SUBJECT: WATTS BAR NUCLEAR PLANT, UNIT 2 - ISSUANCE OF AMENDMENT NO. 42
REGARDING MEASUREMENT UNCERTAINTY RECAPTURE POWER UPRATE
(EPID L-2019-LLS-0000)

Amendment No. 42
License No. NPF-96

TENNESSEE VALLEY AUTHORITY
WATTS BAR NUCLEAR PLANT, UNIT 2

TENNESSEE VALLEY AUTHORITY
WATTS BAR NUCLEAR PLANT, UNIT 2
DOCKET NO. 50-391

Figure 1: WBN, Unit 2 Power Level Relationships

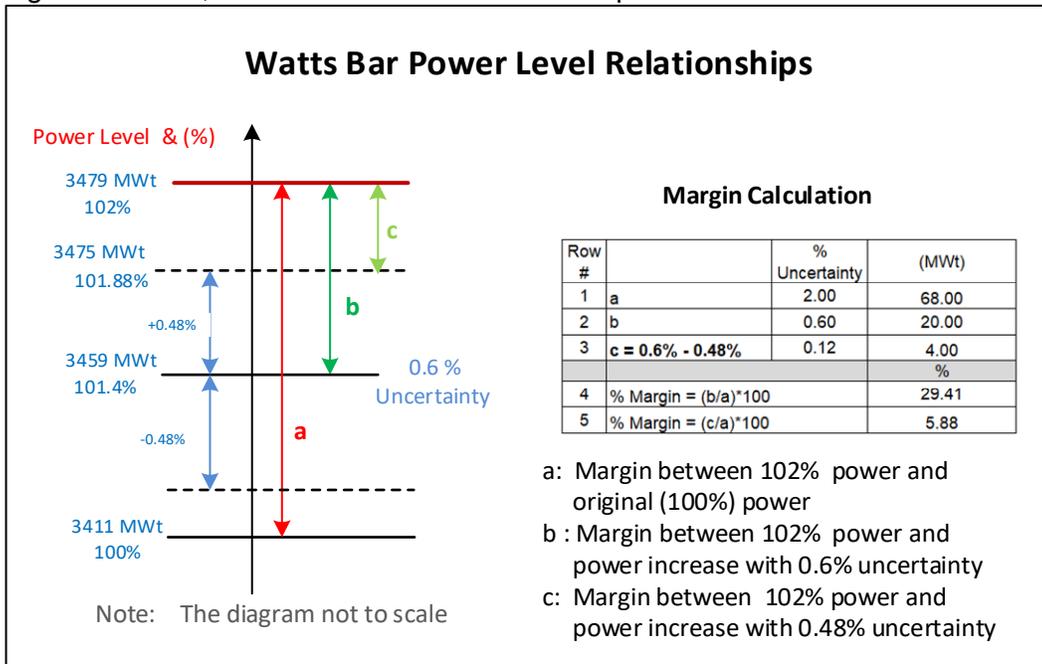
The NRC staff independently verified that the proposed uncertainty of 0.6 percent is more conservative than the flow uncertainty of 0.48 percent. The proposed power increase of 101.4 percent RTP with an uncertainty of 0.6 percent is consistent with the relevant guidance and satisfies the relevant regulatory requirements as described in Section 2.4 of this SE and, therefore, is acceptable. The WBN, Unit 2 power level relationships are illustrated in Figure 1 below.

The NRC staff, therefore, made the following determinations with respect to the proposed power increase of 101.4 percent RTP (with a proposed total uncertainty of 0.6 percent) for the WBN, Unit 2:
